Report on Hydrogeological Impacts
Caused by Aggregate Washing
at the Teedon Pit near Waverly, Ontario

Prepared by: **Wilf Ruland (P. Geo.)**

October 20, 2015

The main focus of my report is an August 2015 document prepared for Cedarhurst entitled “Assessment of Local Well Water Quality Complaints” (hereafter referred to as the “Complaints Assessment Report”). The Complaints Assessment Report was commissioned by Cedarhurst in response to numerous complaints about the off-site impacts of aggregate washing and other activities at the Teedon Pit, and was prepared by Alpha Environmental Services Inc (AES).

Local Well Locations		
Date: July 2015	Project: AES 15-08	Figure 2
Drawn: FRC	Scale: NTS

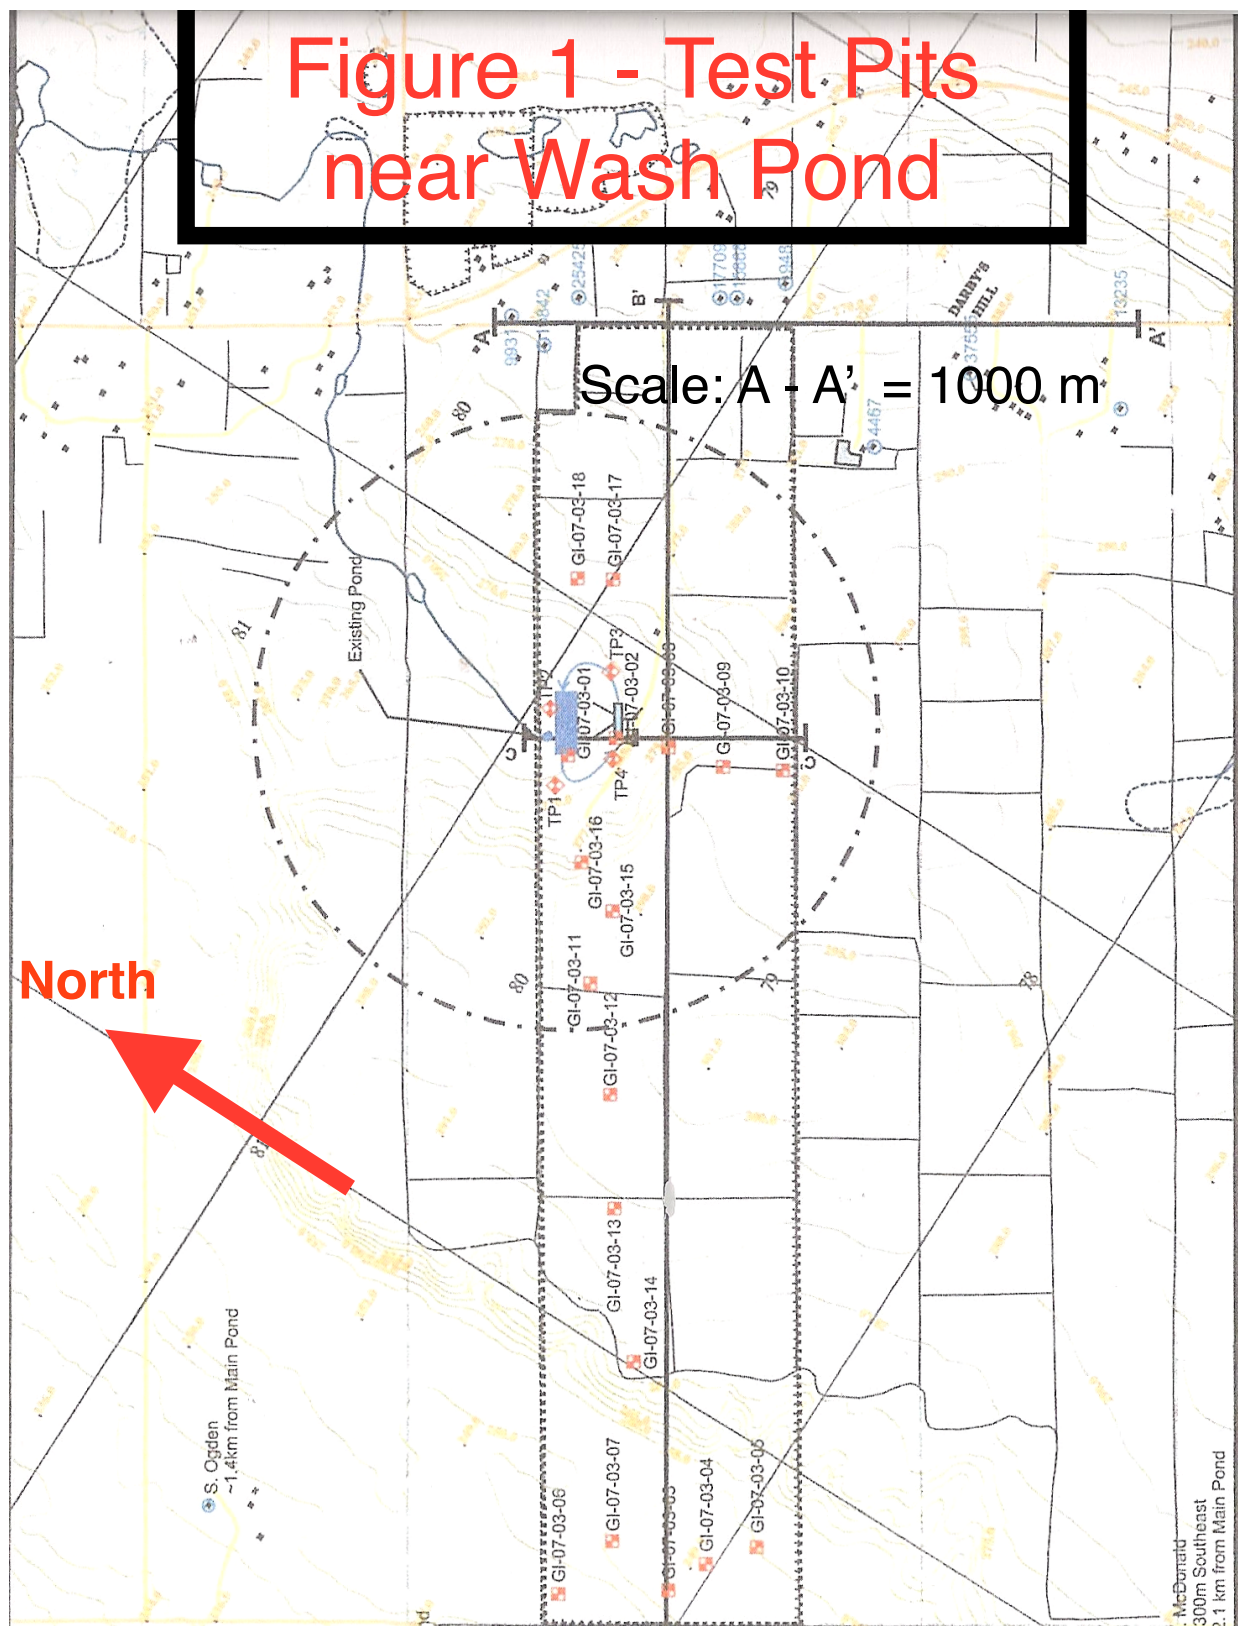
The map on Figure 2 of the Complaints Assessment Report shows that there are 4 wells on the west side of wash pond in the area between the pond and Marshall Road (the road on which the wells of my clients and several other families with complaints are situated):

The Cedarhurst monitoring well network is shown on Figure 2 of the Complaints Assessment Report, which I have reproduced and included in this report - also as Figure 2.
